1.1 ATKINSON STREET OPTIONS – CYCLING CONNECTION – SCOTCHMANS CREEK TRAIL TO DJERRING TRAIL, OAKLEIGH
(SJW/RA: F18-34454)

The purpose of this report is to present and discuss the findings of the peer review undertaken to assess issues raised with the proposed two-way cycleway along Atkinson Street, Oakleigh. This report also presents various options developed in response to the peer review and recommends a preferred option.

Figure 1. Cross section of two-way cycle track, east side - parallel parking both sides - Option 1

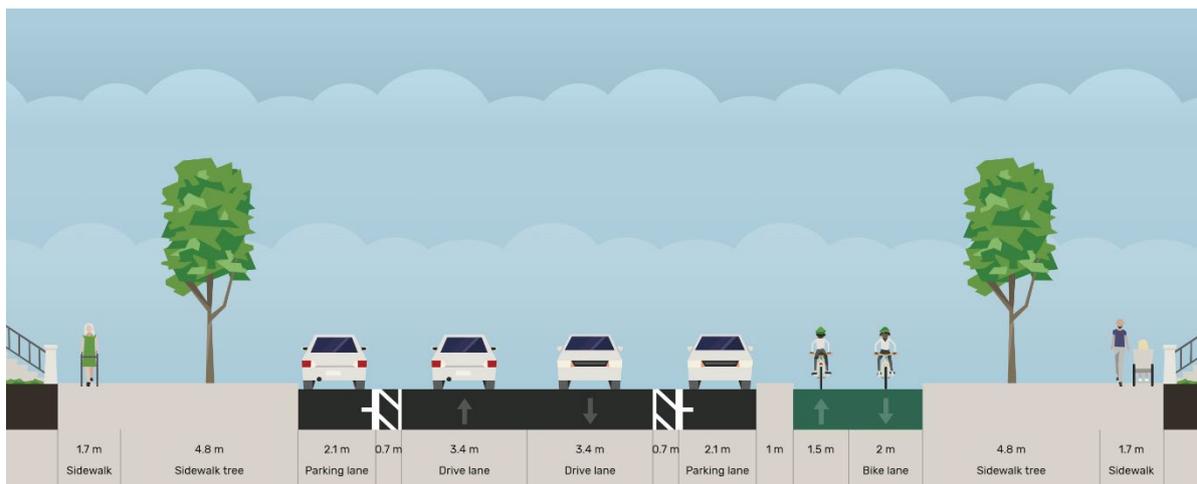
- The width of the cycle track increased from 2.7m to 3.5m, which provides an effective width of 3.0m taking into account the bluestone channel is difficult for cyclists to traverse and a wider path helps to

avoid pedal strikes. The 3.0m width meets the standard for a Type 1 path. This allows for the “wobble factor” of a rider negotiating the steeper section of Atkinson Street and allows for the speed differential between a less confident person riding and regular riders.

- A 0.6m buffer was considered acceptable as an absolute minimum where there are constraints, however it was recommended that in a permanent design additional space would allow for a landscaped buffer to be installed. The Austroads guidelines indicate that a 1.0m or greater physical separation for motor traffic is desirable. Waste bin collection at the kerbside will be difficult to achieve with bins required to be collected in and around parking lanes or cycle track buffer. A 1.0m buffer will allow for the larger bins to be accommodated with some space for movement during the bin collection. The peer review recommended that any trial utilise a bolt-down kerb separator with sufficient buffer either side to avoid kerb strikes by cars and pedal strikes by people riding.

- Currently the bike lanes act as a buffer for drivers exiting their vehicle without having to wait for a gap in traffic. The review suggests that the lack of buffers is a particular concern with the higher speeds and volumes associated with Atkinson Street. While this is half the width of the current bike lane, it will still allow a person to safely exit their vehicle.

- The existing width of the travelling lanes is proposed to be retained for operational functionality and ability to accommodate heavy vehicles, including buses. In order to provide for the increase in width of various components of the cycle track, there is a need to convert the existing angled parking on the west side of the road to parallel parking. This allows for the existing width of the travelling lanes to be maintained.

- Stantec’s review of current thinking indicated that while 3m is the absolute minimum for parking setbacks, a 5m setback is strongly advised, particularly with a bi-directional track. It suggests that while familiarity with the facility outside residential properties will eventuate, the increased speeds of people riding downhill or on electric-assisted bicycles and scooters will still pose a risk if visibility is compromised. This is especially the case with drivers turning right who may struggle to see someone cycling if they are behind parked

cars. The risk is also increased on downhill sections of Atkinson Street.

- Concern was raised in the peer review that the visibility of drivers in side streets to approaching traffic in Atkinson Street is reduced considerably in the proposed design and is up to 10m less than existing conditions. It was strongly suggested that the application of a 42m sight line splay from the driver's position looking in both directions to approaching traffic is necessary, in accordance with Australian Standards. As a result of this requirement, a number of parking spaces in Option 1 would need to be removed.

1. Effective 3.0m wide cycle track.

2. Provide 1.0m buffer between cycle track and parallel parking, east side

3. Provide 0.7m buffer between the parking lane and the travelling lane, both sides.

4. Maintain existing 3.4m travelling lanes.

5. Require 5m setback to each driveway on the side of the cycle track and 3m on the opposite side to assist driver sightlines to cyclists when entering.

6. *Require 42m Stopping Sight Distance (SSD) to the side streets in accordance with current standards.*

Figure 2. Cross section of two-way cycle track, east side – no parking east side, retain angle parking west side - Option 2

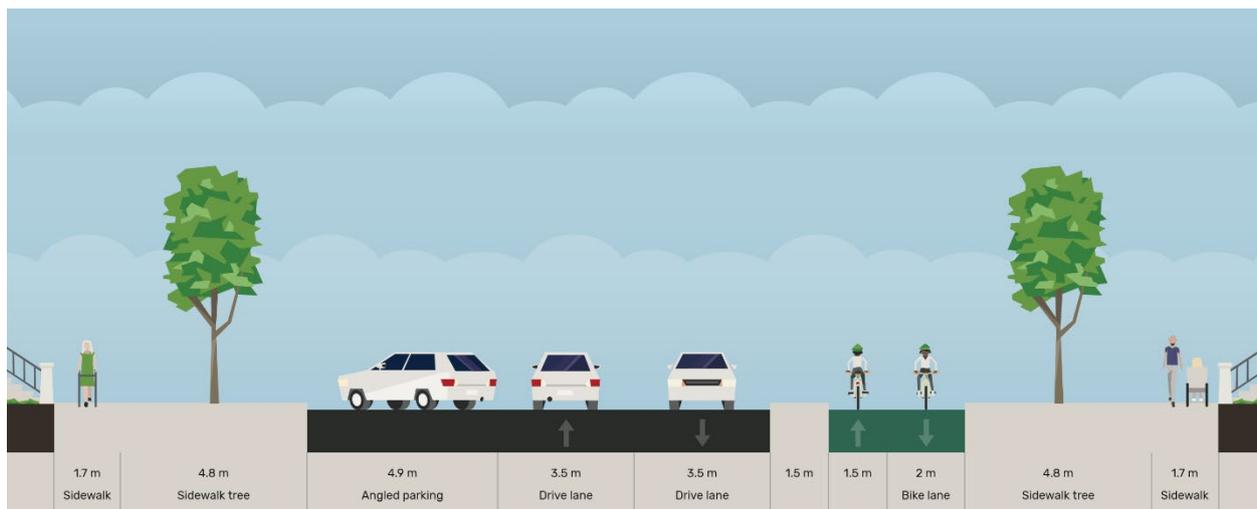
The main difference between Option 1 and Option 2 is that Option 2 removes all blockages due to parked vehicles for drivers entering and exiting properties and side streets, and allows clear unobstructed vision for cyclists, residents and motorists along the east side of Atkinson Street. This results in better safety outcomes than Option 1 while still maintaining the functionality of a two-way cycle track, supplies the highest parking yield of all the options, has less impact to physical infrastructure (as no changes are required on the west side) and is expected to have a lower implementation cost than the other options. Waste collection will be simplified in this option.

1. Provide 1.5m wide buffer between the cycle track and the travelling lane.

- This allows for an increased buffer to accommodate waste bin collection clear of the cycle track with bins stored within the buffer.

- Similar to Option 1, to be installed where possible.
8. **Increase width of travelling lanes to 3.5m.**
 - Alternatively a small buffer of 0.2m could be retained at the rear of the existing angled parking spaces on the west side to facilitate reverse movements.

Figure 3. Cross section of two-way cycle track, west side – parallel parking both sides - Option 3

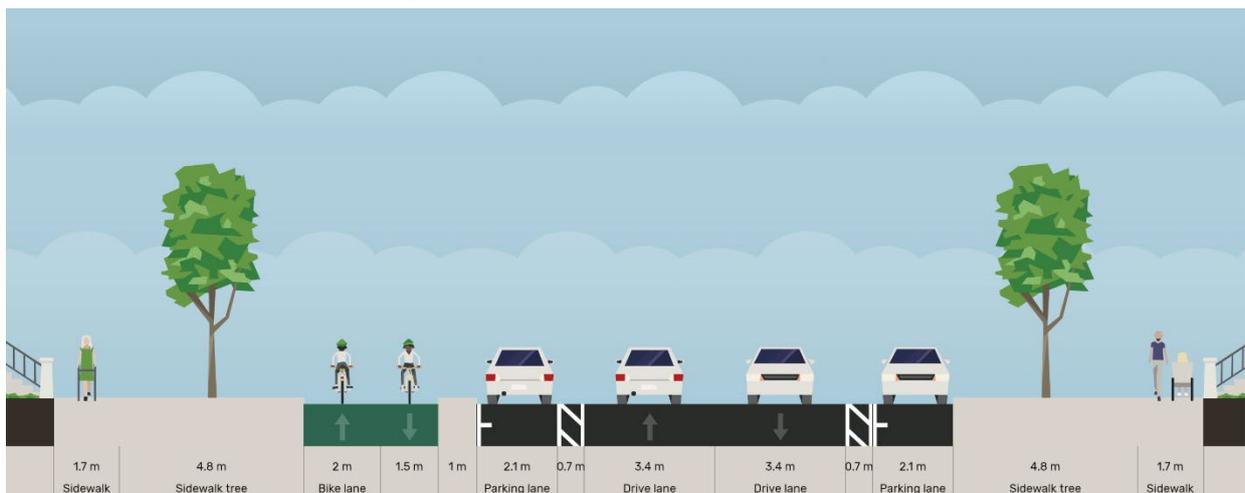
- 2. East side parking 11 spaces (46 existing).**
 - Stantec has raised concerns about the existing sight distance at side streets which does not meet current standards. Residents also raised safety issues exiting their driveways on the east side of Atkinson Street due to inadequate sight distance. There is now an obligation that, even if parallel parking on the east side is retained, a review of sight lines for side streets and driveways is required for safety reasons. Consequently, it is expected that around 11 parking spaces on the east side will be kept.

- There is insufficient road space at the Dandenong Road end to allow for a cycle track with major gas infrastructure effectively prohibiting the ability for an off-road option. The Atherton Road end is also problematic as the facility would not be able to start until north of the Atkinson Street car park access and a shared off-road path from Atherton Road to this access cannot be achieved due to traffic signal infrastructure.

- 6. Cyclists forced to cross to the east side at Atherton Road.**
 - People cycling will need to shift sides to continue on the broader cycling connection, creating a less convenient, indirect link.

- 7. Reduced comfort for people cycling due to steeper crossfall on west side.**
 - The crossfall on the west side of Atkinson Street is steeper than the east side which is expected to reduce comfort for people cycling.

Figure 4. Cross section of one-way cycle track both sides - parallel parking both sides – Option 4

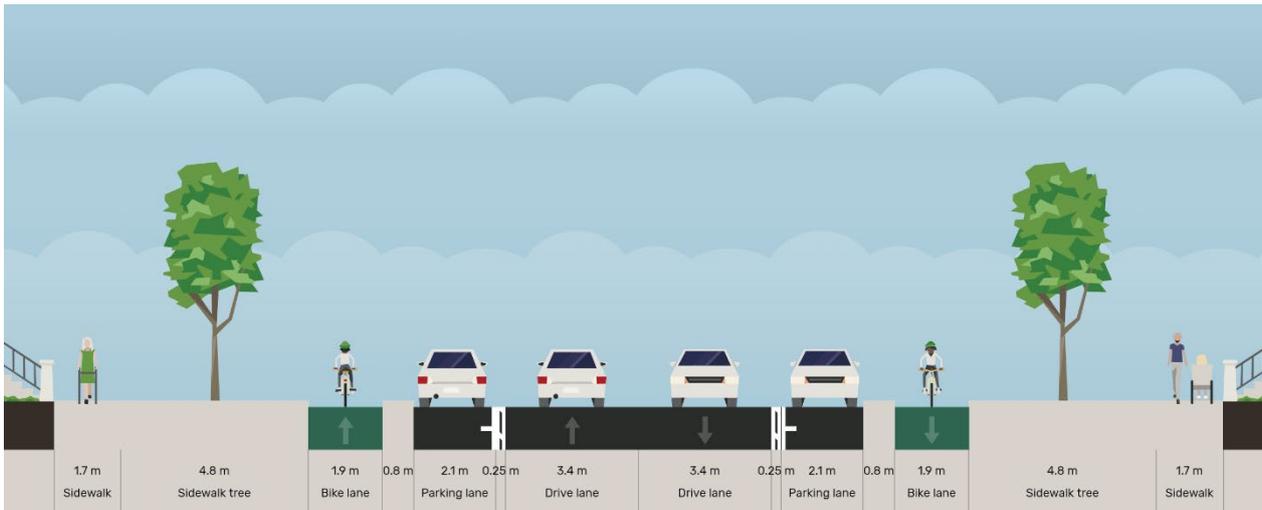
- This is less than the desirable width of 1.0m and would just accommodate Council's larger bins if placed carefully.

- This would not be sufficient for drivers to exit their vehicle without having to wait for a gap in traffic.

1. *Effective width of one-way cycle track 1.4m.*

2. *Buffer width of 0.8m between the cycle track and the parking lane.*

3. *Provide a 0.25m buffer between the parking lanes and travelling lanes.*

4. *Provide 5m setback to each driveway in the direction of flow.*

4. Atherton Road intersection – See also Point 5 below

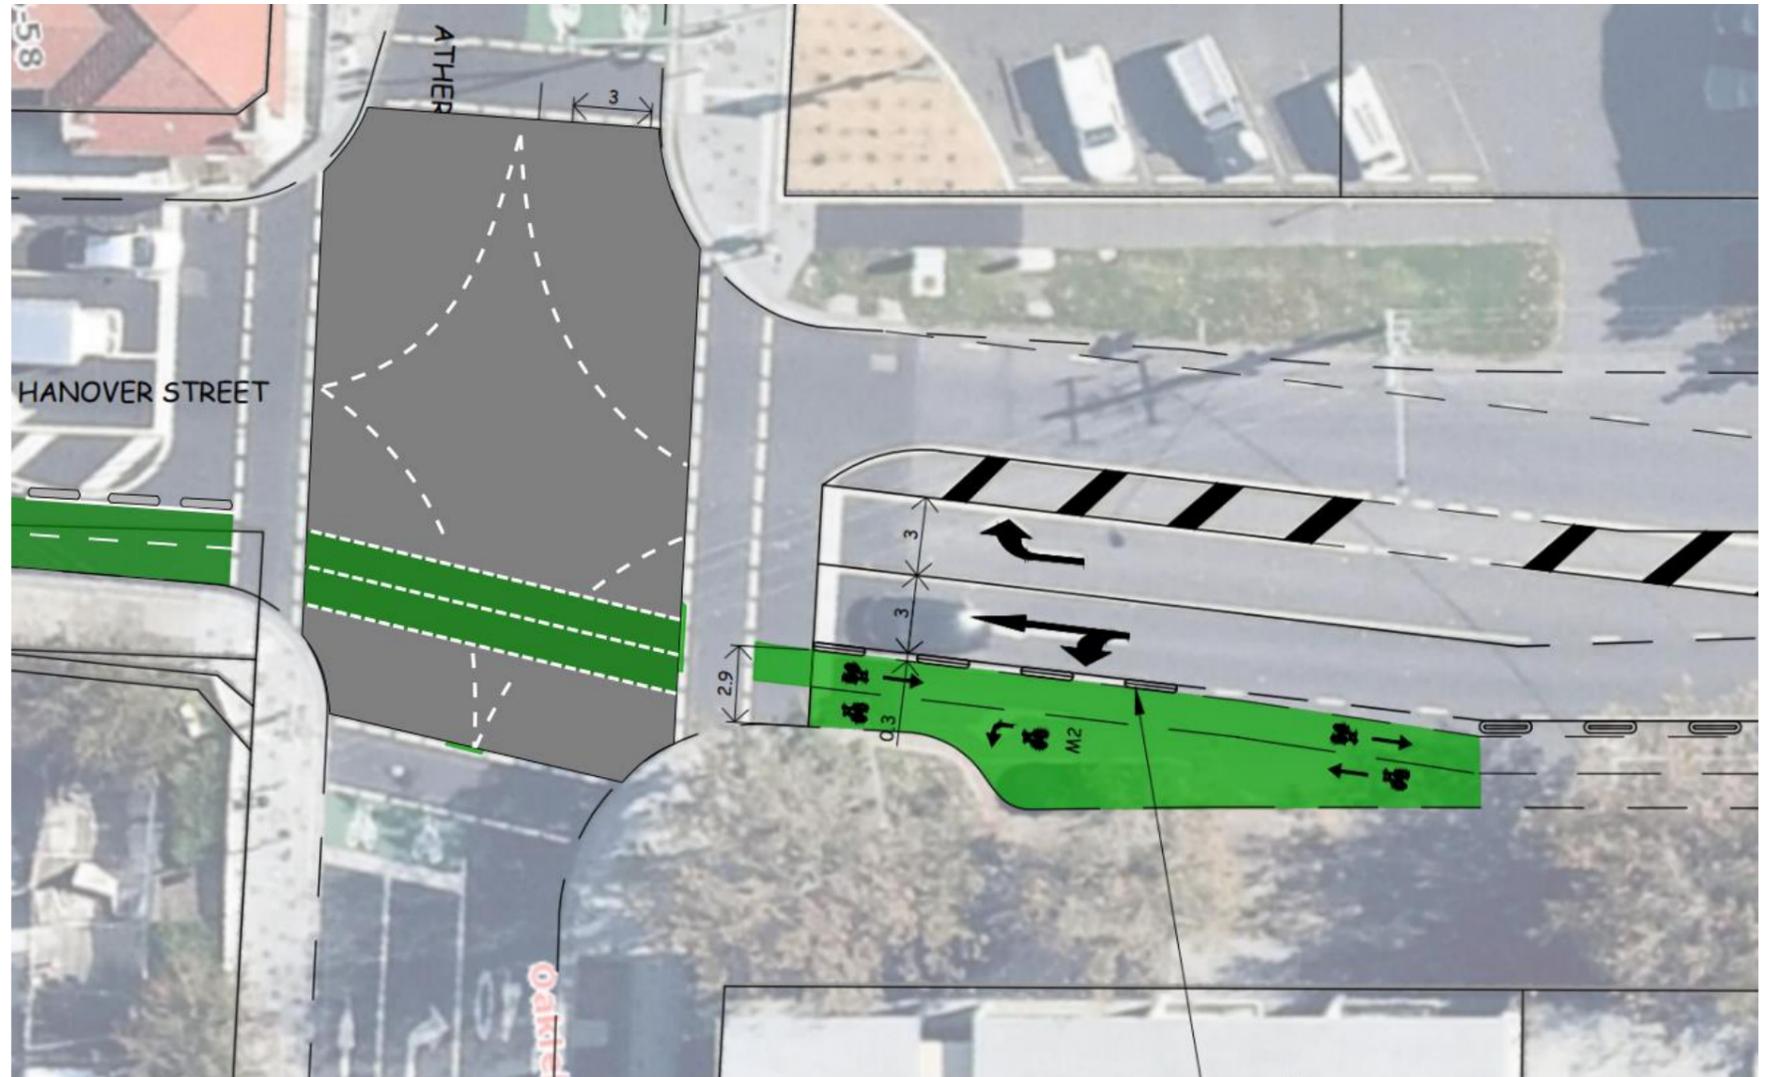
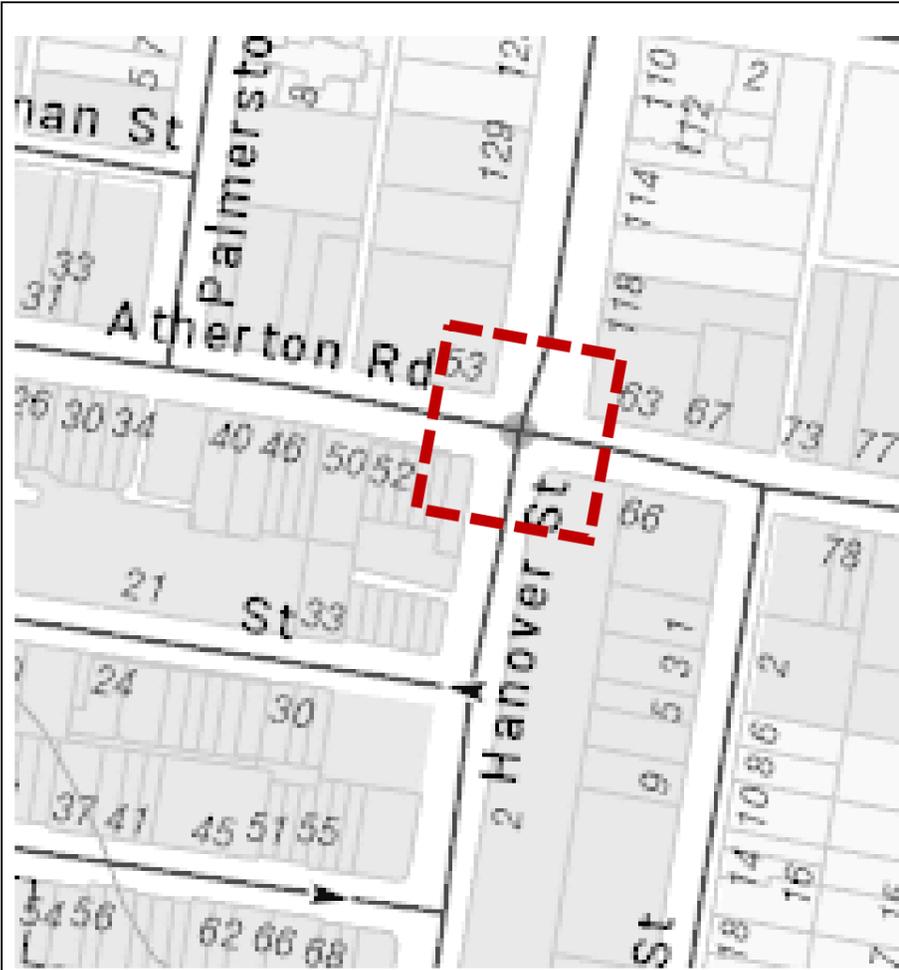
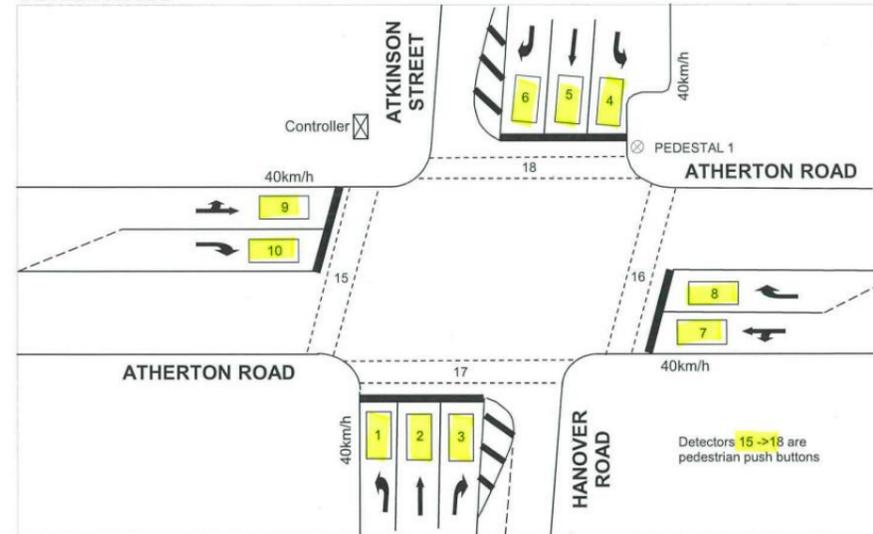
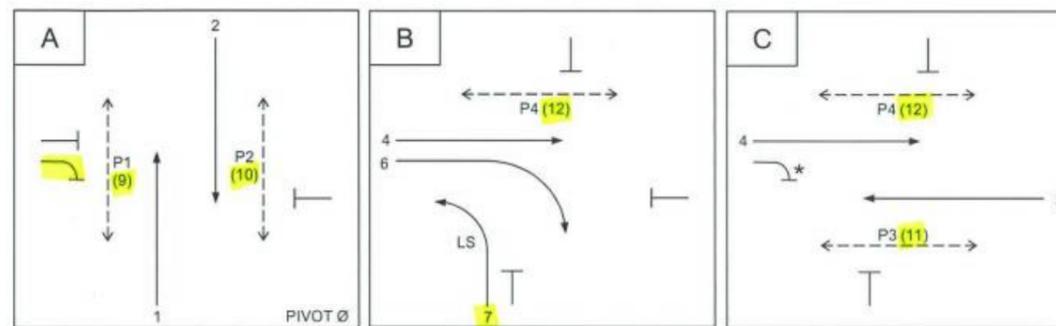
- a. Extend cycleway through intersection south to Hanover Street – potential stand up lane configuration on Hanover Street

- Cycleway is compatible with existing phasing
- Three-aspect bicycle lanterns should be installed to duplicate north-south vehicle movement in Phase A
- Signalling loops in cycleway are not strictly necessary as bicycle movement occurs during pivot in Phase A

- Funding permitted, traffic signals should be amended to fully control the right turn from Hanover Street south into Atherton Road east

3. Dandenong Road intersection

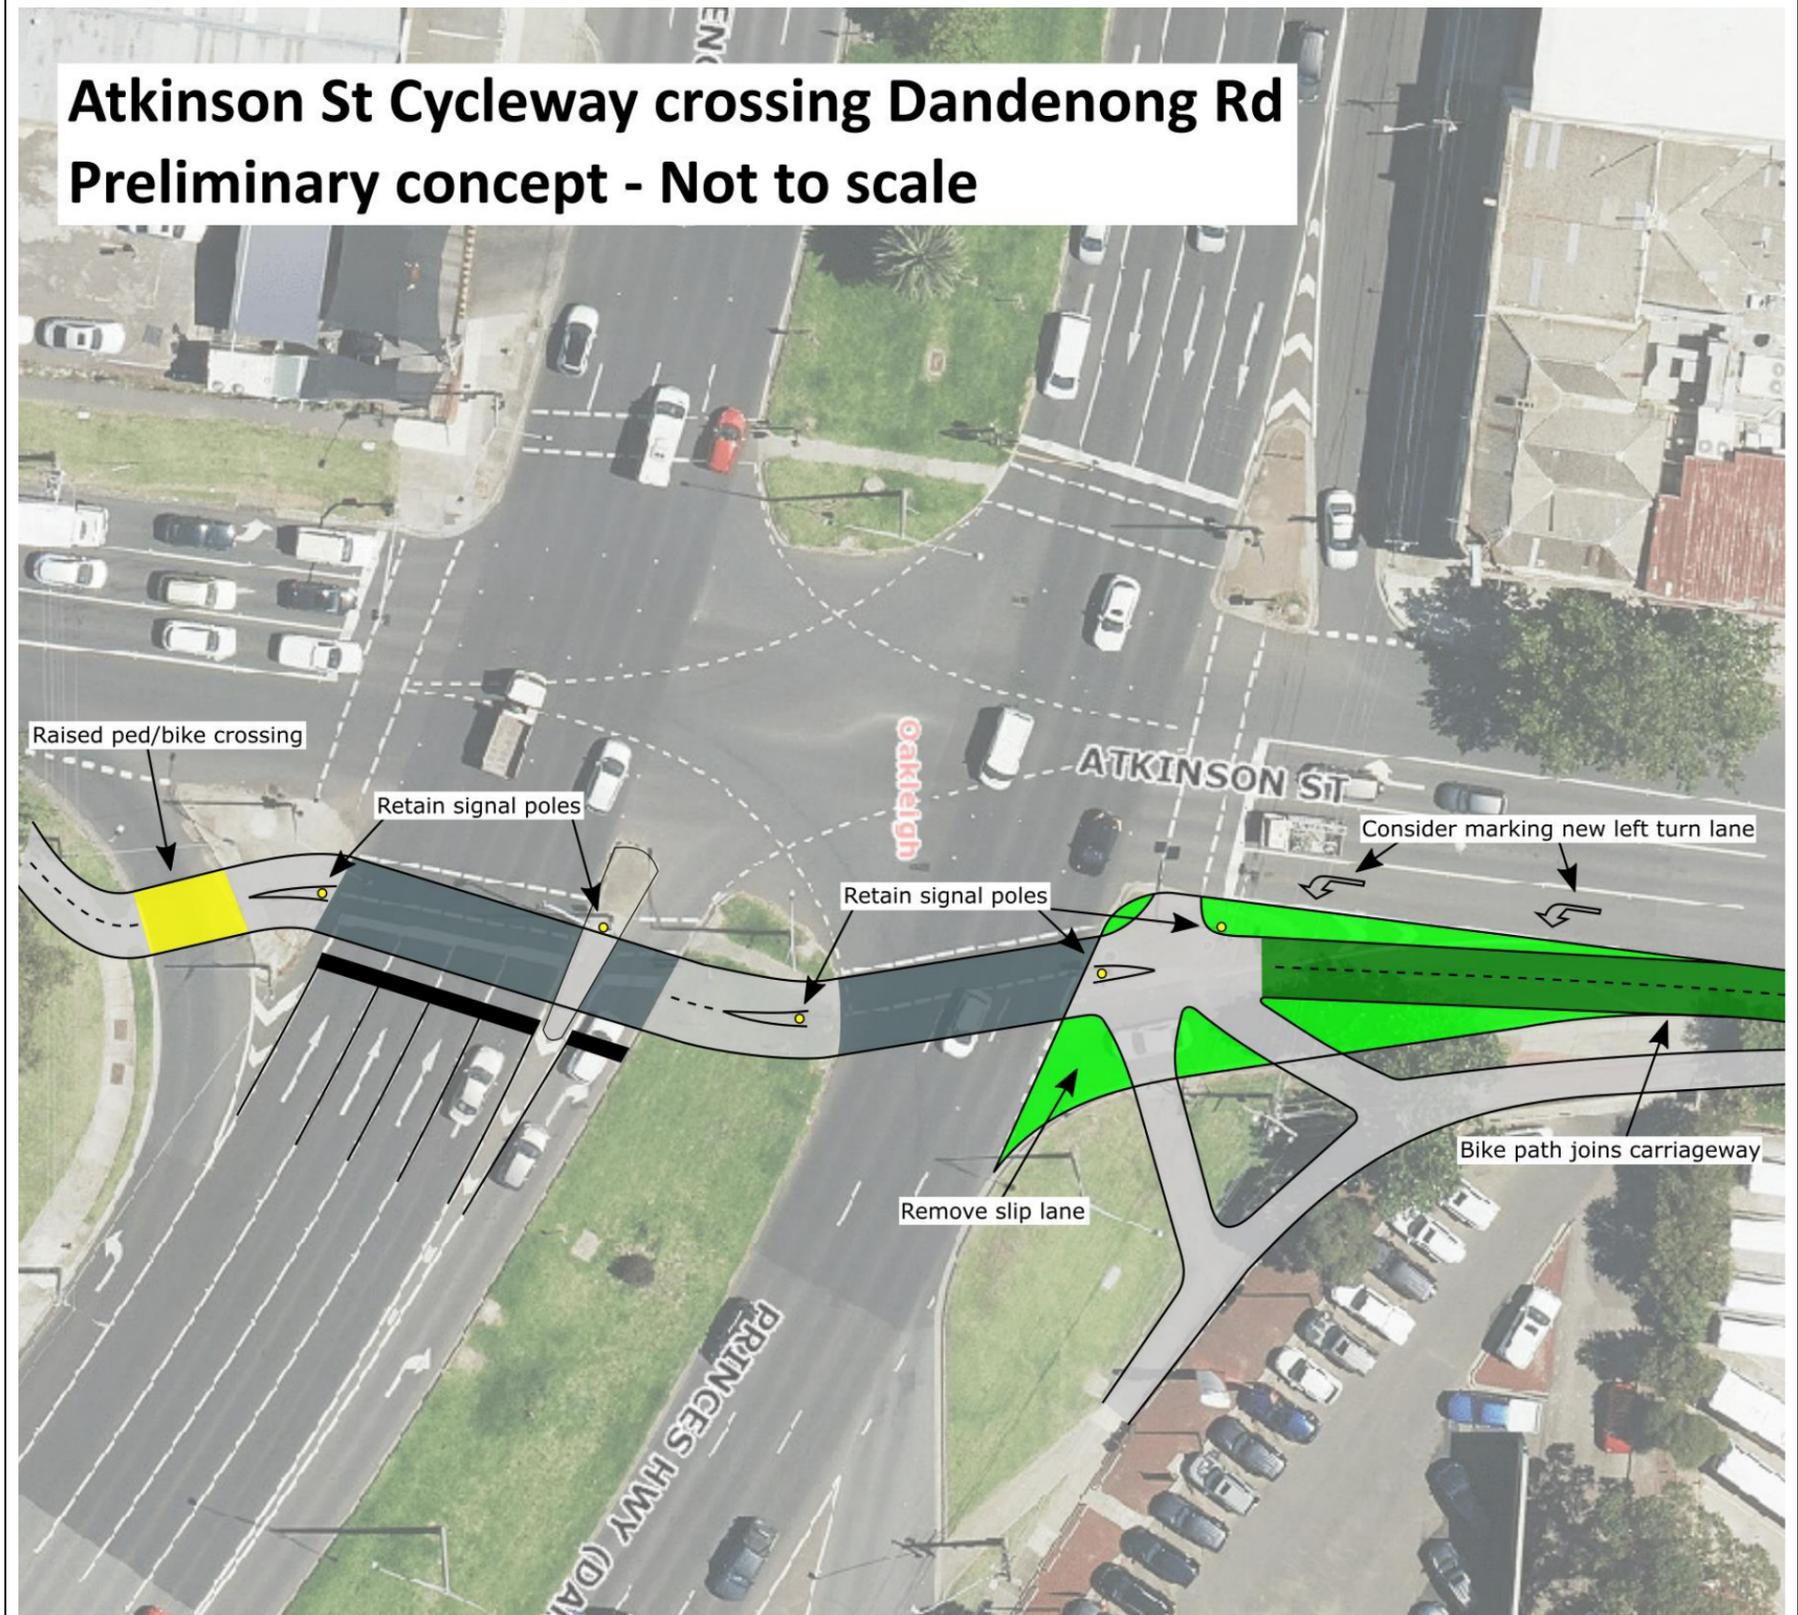
- a. Engage engineer to determine viability of concept shown
- b. Construct shared crossing on eastern side
- c. Remove slip lane on north-east corner
- d. Retain as much signalling and utility infrastructure as possible – install two-aspect bicycle lanterns duplicating pedestrian lanterns
